ADDENDUM 1

RFP 17-16—"LEVY BUILDING ROOF REPLACEMENT"

CITY OF HAMMOND, LOUISIANA

Detail 1—Parapet Wall Detail

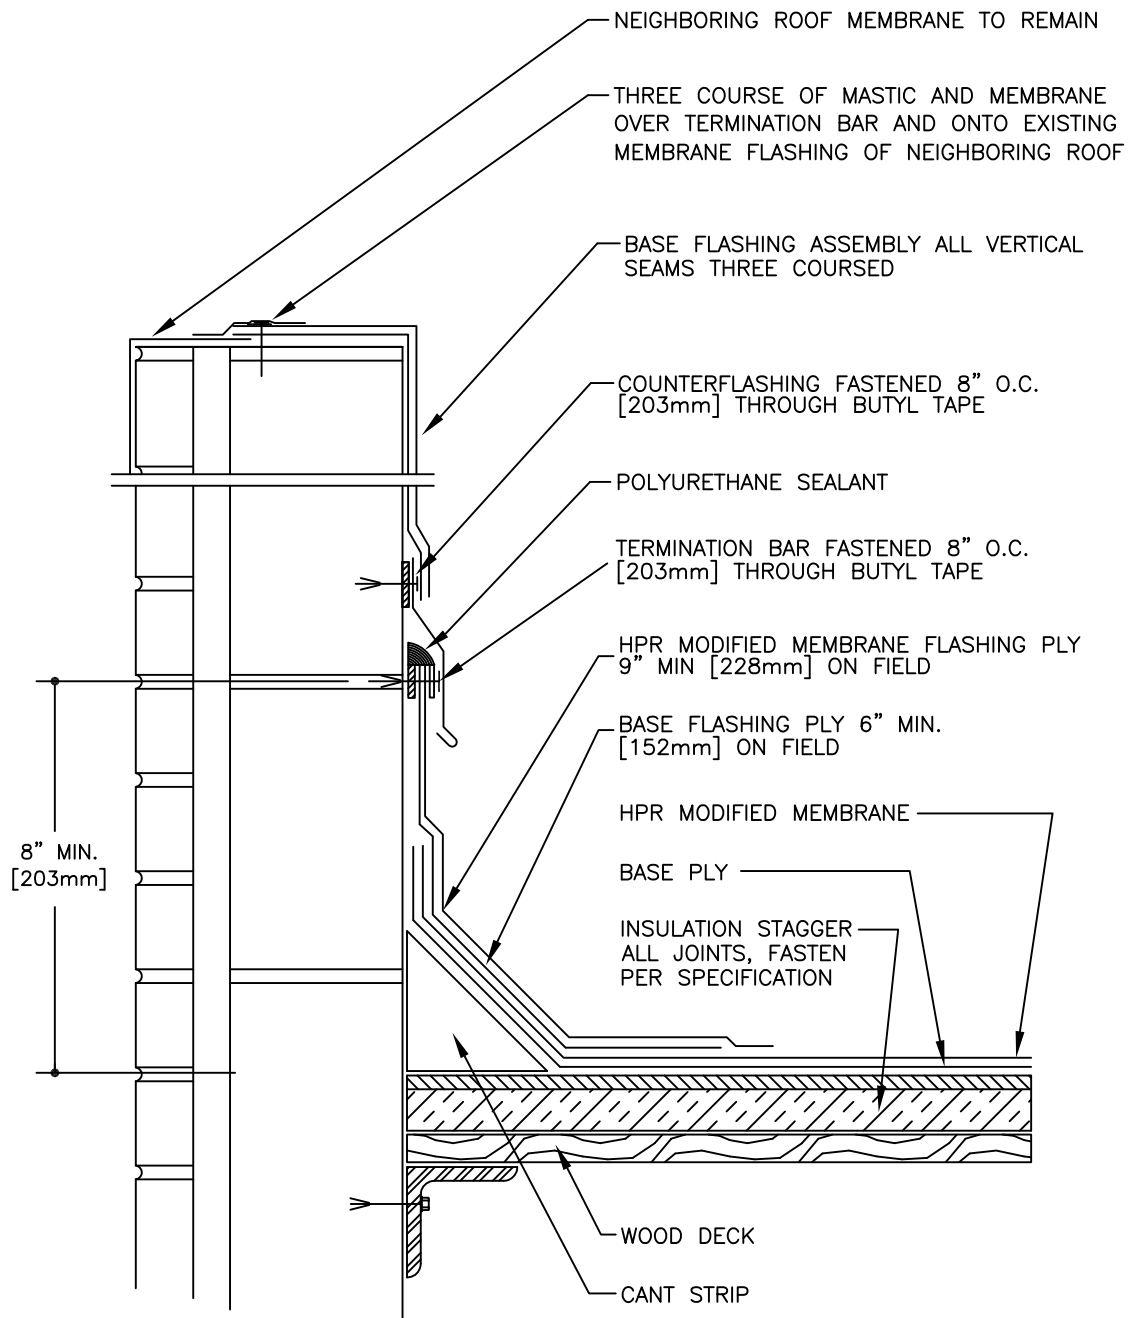
Delete the originally issued Detail 1—Parapet Wall Detail and insert the revised Detail 1—Parapet Wall Detail included as Attachment A.

NOTE:
WALL HEIGHT VARIES
ALL VERTICAL LAPS SHALL BE THREE COURSED

Detail 4—Low Roof Parapet Wall Detail

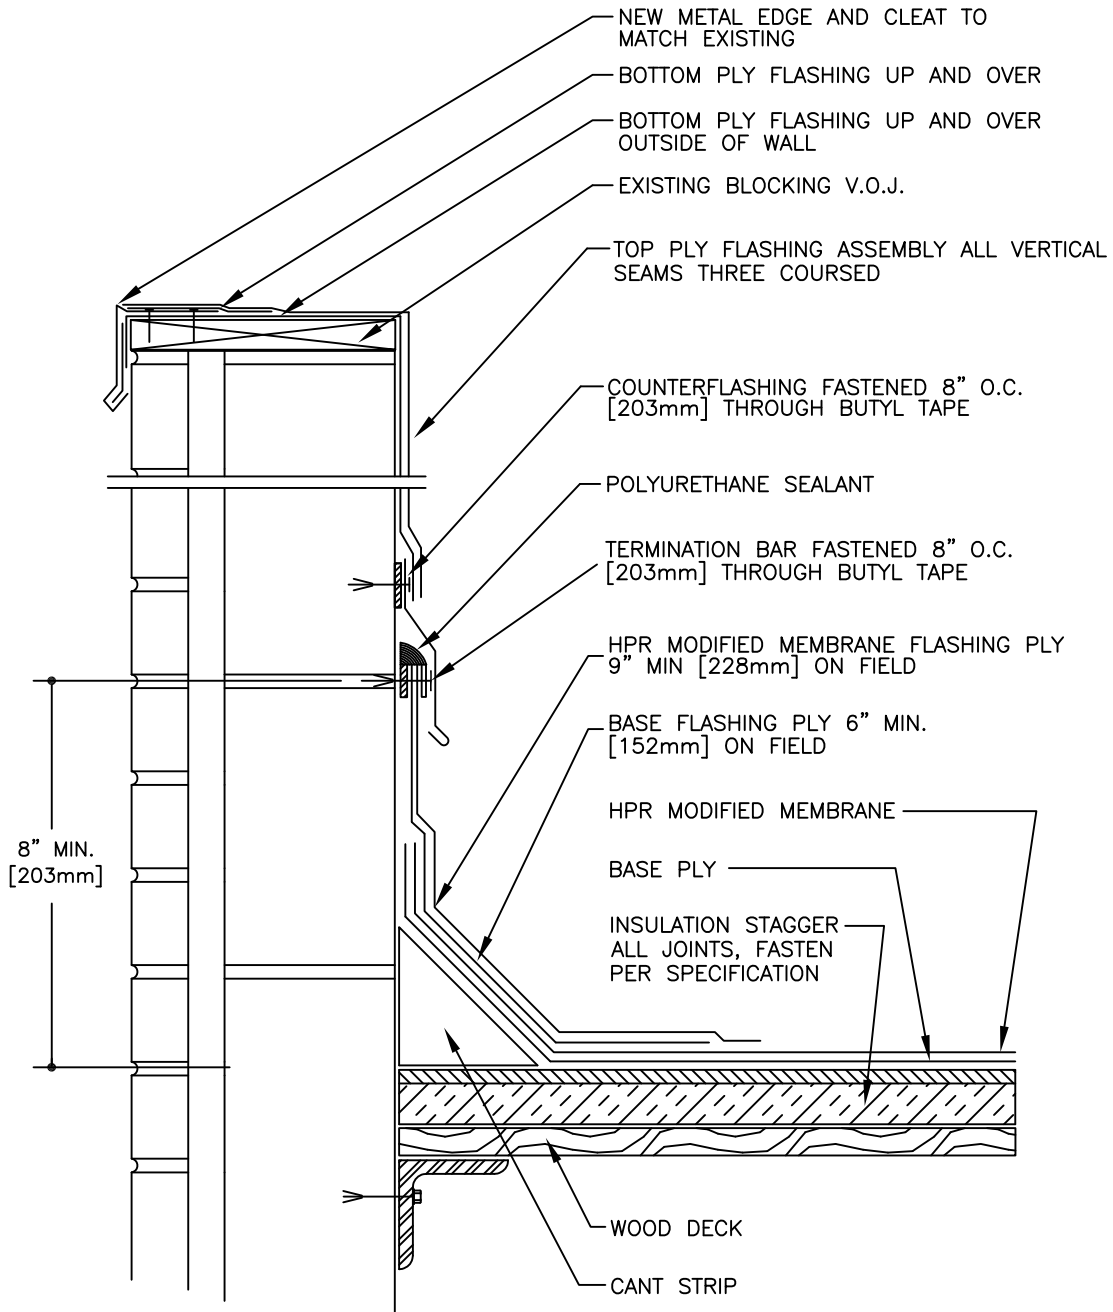
Insert the following after Detail 3—Parapet Wall Detail: Detail 4—Low Roof Parapet Wall Detail included as Attachment B.

NOTE:
WALL HEIGHT VARIES
ALL VERTICAL LAPS SHALL BE THREE COURSED

CONTRACTOR SHALL FABRICATE AND INSTALL NEW METAL TRIM AROUND LOWER ROOF AREA TO MATCH EXISTING PROFILE. OWNER SHALL PICK THE COLOR FROM A STANDARD KYNAR 500 COLOR ROOF CHART.

Typical Curb Detail

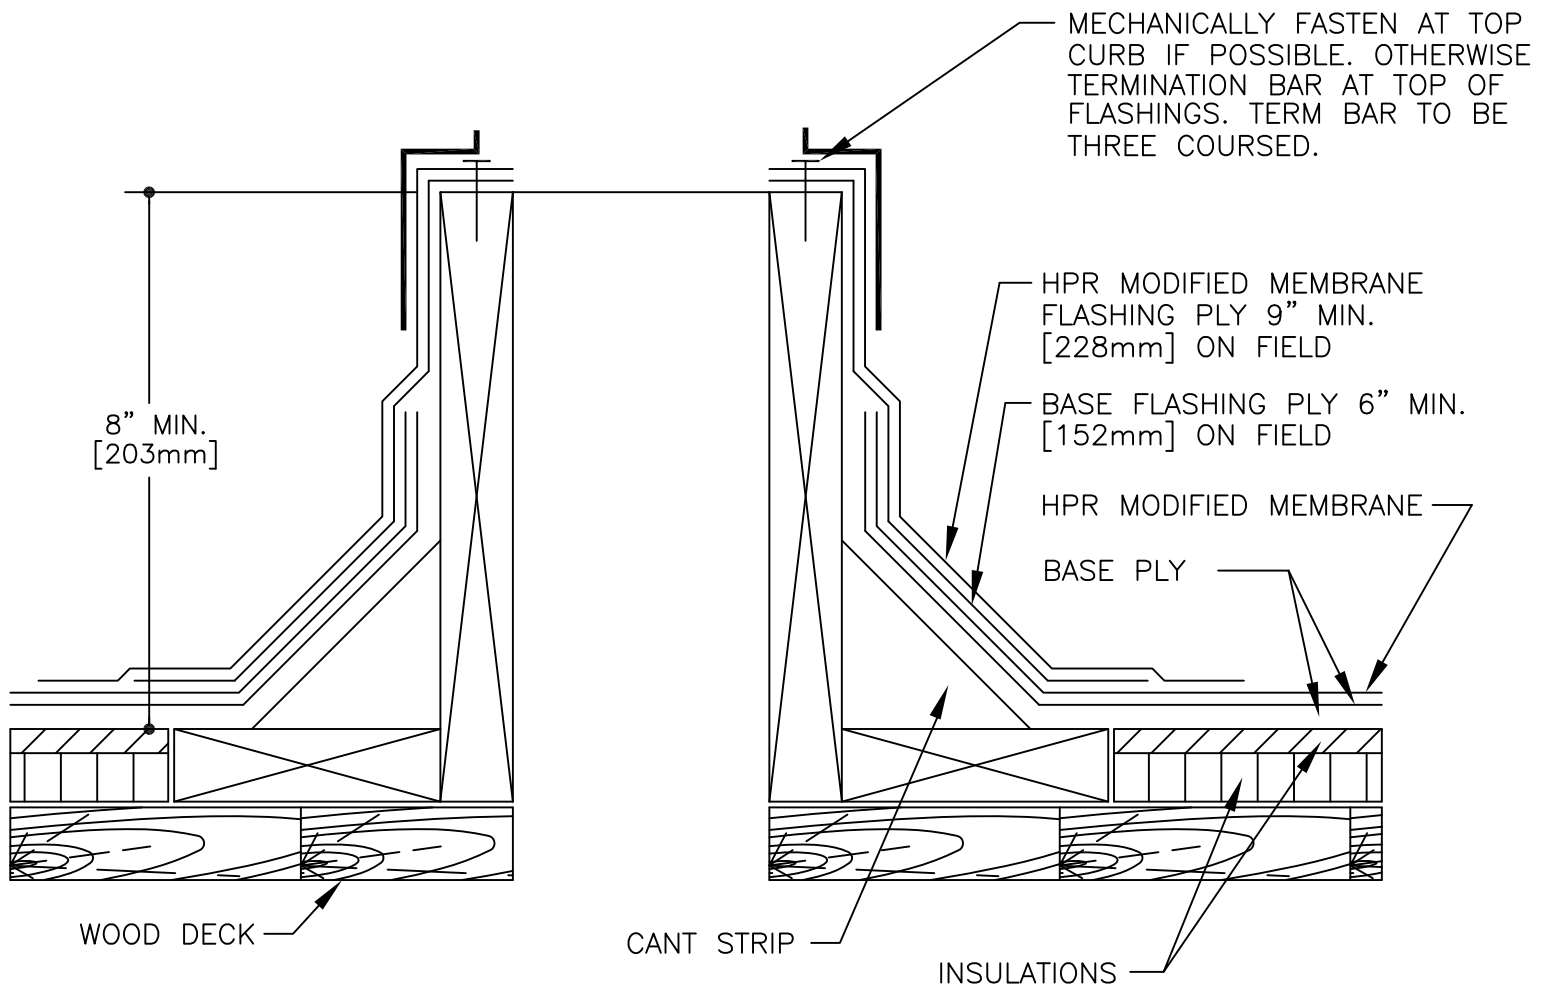
Also insert the following after the detail Through Wall Scupper: the detail Typical Curb Detail included as Attachment C.

NOTE: CONTRACTOR RESPONSIBLE TO RAISE ALL CURBS TO A MIN. 8" ABOVE NEW ROOF HEIGHT. COUNTERFLASHING SHALL BE INSTALLED IF REQUIRED.
